RE: A&M Project # 1830-01B
WRPD Application
Plain Street Drainage Outfall
Response to Peer Review Comments

On behalf of our Applicant, Town of Middleborough Department of Public Works, Allen & Major Associates Inc. (A&M) would like to provide responses, summarized below as related to a peer review memo prepared by Atlantic Design Engineers, Inc. (ADE) dated April 28, 2016. Revisions to the site plan drawings incorporating these changes are denoted as revision 1 dated May 13, 2016.

PROJECT: STORMWATER MITIGATION PLAN
 OFF PLAIN STREET
 MIDDLEBOROUGH, MA

DRAWING TITLE: DRAINAGE MODIFICATION PLAN
 SHEET NO.: C-1

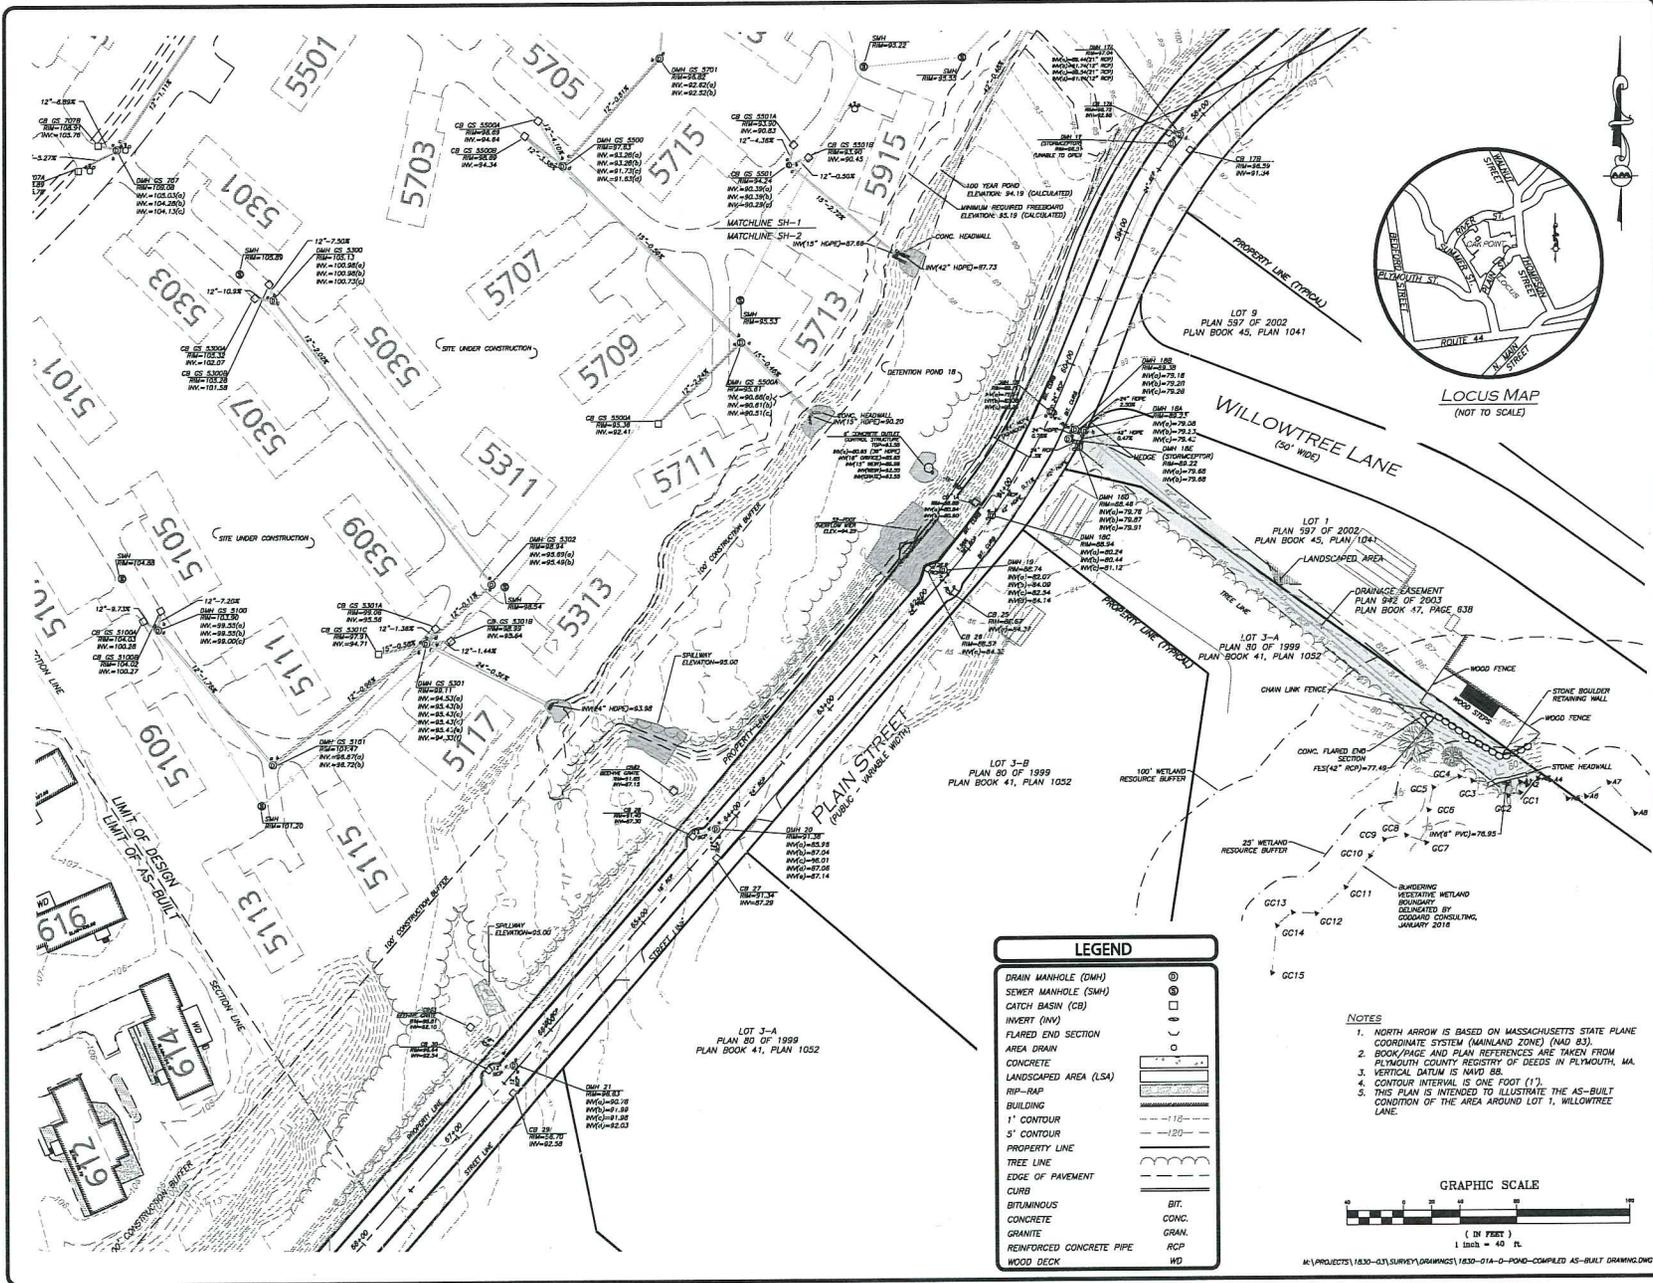
Comment 3: It is recommended that erosion protection/rip-rap be provided at the roof drain outfall from the adjacent dwelling. It appears to be just daylighting onto a proposed 3:1 slope.

6. The viewport of the proposed conditions plan (C-1) should be expanded to include some of the continuation of wetland flags beyond Flag A-3 as requested by Ms. Cassady during a working session at the Planning Board office on March 3, 2016.
7. It should be noted that as part of our ongoing peer review consulting for the Middleborough Planning Board, Nitsch Engineering has also expressed significant concerns regarding the upstream erosion and sediment control measures associated with the ongoing construction at Hometown Oak Point in Phase VII Section 2. These were most recently documented in field reports prepared by Nitsch Engineering for the Planning Board (and copy sent to the Conservation Commission) dated March 18, 2016 and March 3, 2016. It should be noted that these areas ultimately discharge to this 42-inch outfall.

Response 3: The plans have been revised as requested.

RIP RAP APRON
NOT TO SCALE 9

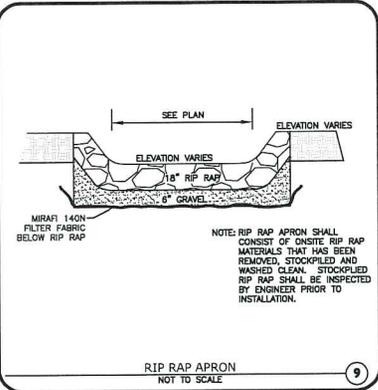
Comment 4: It is recommended that the rip-rap at the new box culvert outfall be flared out in front of the wing wall to the northeast and also be extended around the side of the box culvert to the southwest.

Response 4: The plans have been revised as requested.

10.5 FT. x 6 FT. PRECAST CONCRETE BOX CULVERT
NOT TO SCALE 4

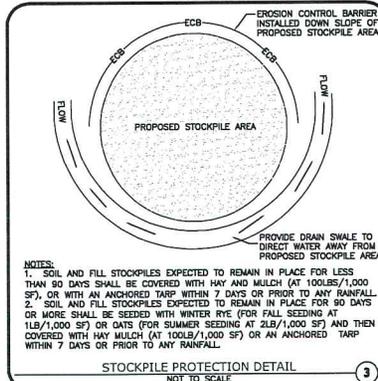
Comment 5: Provide a detail for the connections of the 42" pipe to the box culvert.

Comment 7: Provide a detail for the wing wall. Also, it is recommended that the wing wall be extended to the existing retaining wall. It appears there is a 2' - 3' gap between the walls?

Response 5: The 42" pipe will be mortared to the box culvert to provide a watertight connection.

Response 7: The wing wall is a precast section that will be attached to the end of the box culvert. Shop drawings will be provided by the manufacturer prior to fabrication. The wall has been extended as requested.
